THE TWENTY SUBDIVISION

APPLICATION NUMBER 7 DATE October 15, 2015

REQUEST Subdivision

DETAIL SITE PLAN

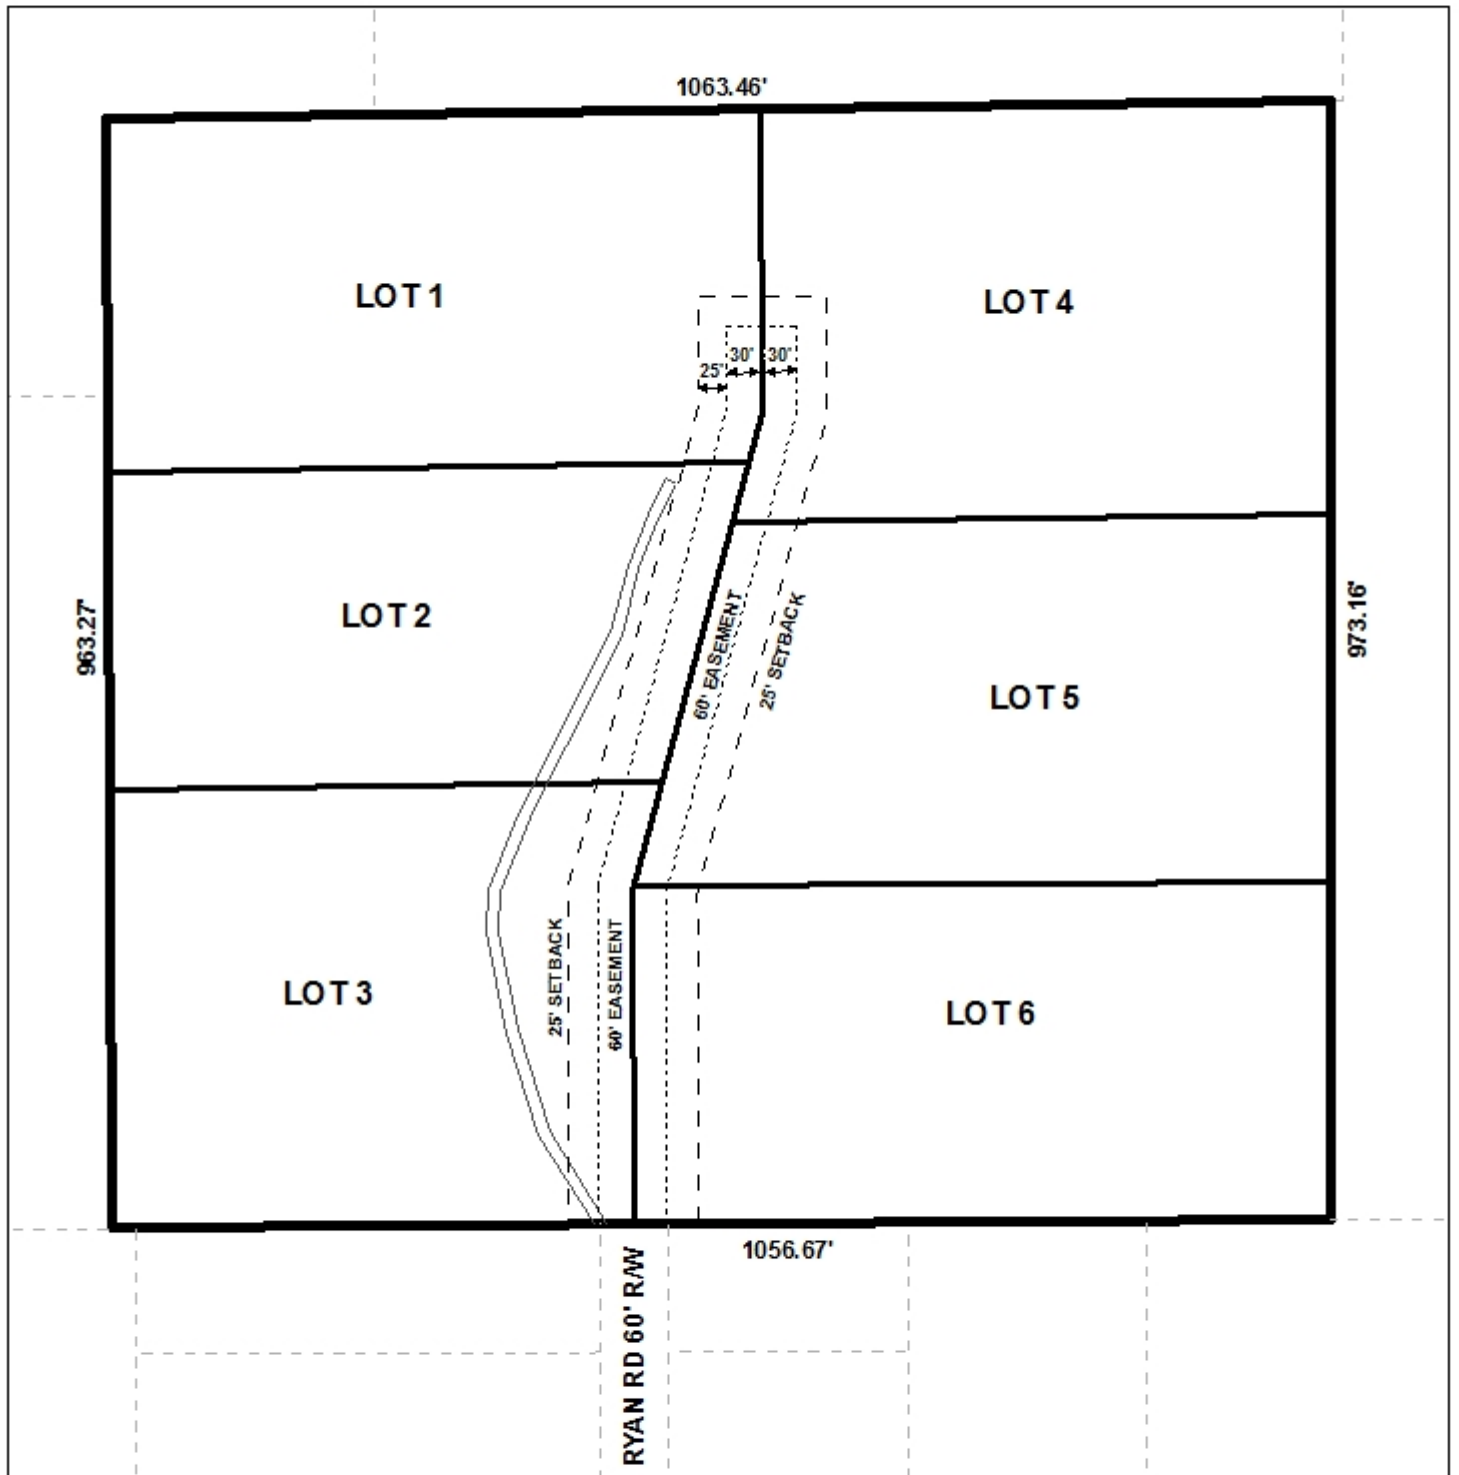
The intent of this application is to create 6 legal lots of record, on an existing private road, from 2 metes-and-bounds parcels. It should be pointed out that the applicant proposes a family subdivision; however, Section VIII.D. of the Subdivision Regulations defines a family division to consist of five (5) or fewer lots. As such, a waiver of this section would be required for approval.

In accordance with the Subdivision Regulations, all proposed lots exceed the minimum lot size requirements and the 25' minimum building setback line is depicted on the preliminary plat. The lot size information and setbacks should be retained on the Final Plat, if approved.

The proposed subdivision abuts the northern terminus of Ryan Road; however, the applicant proposes access for all 6 lots via a common driveway within a 60' wide ingress/egress and utility easement. Although no dedication is necessary, full compliance with Section VIII.E.2. of the Subdivision Regulations should be required. More specifically, this section addresses the provision of adequate stormwater drainage facilities to prevent excessive runoff, road design and easements, legal documentation, signage, letters and notes on the Final Plat. The private street should also be detailed and depicted on the Final Plat, if approved.

As a means of access management, all proposed lots should be limited to 1 curb-cut each to the common driveway, with the size, design and location to be approved by Mobile County Engineering and conform to AASHTO standards.

As mentioned above, there is a 60' wide ingress/egress and utility easement on the site. As such, a note should be placed on the Final Plat stating that no permanent structure(s) shall be placed or erected within any easement, if approved.

With a waiver of Section VIII.D. of the Subdivision Regulations, the application is recommended for tentative approval, subject to the following conditions:

- 1) Compliance with Section VIII.E.2. of the Subdivision Regulations, to include all specified design and construction standards, utility easements, notes on plats and other requirements in said section;

- 2) Retention of the lot size information and 25' minimum building setback on the Final Plat;
- 3) Placement of a note on the Final Plat stating that each lot is limited to 1 curb-cut each to the common driveway, with the size, design and location to be approved by Mobile County Engineering and conform to AASHTO standards;

- 4) Placement of a note on the Final Plat stating that no permanent structure(s) shall be placed on erected within any easement;
- 5) Placement of a note on the Final Plat stating (*Any lots which are developed commercially and adjoin residentially developed property must provide a buffer, in compliance with Section V.A.8. of the Subdivision Regulations.*);
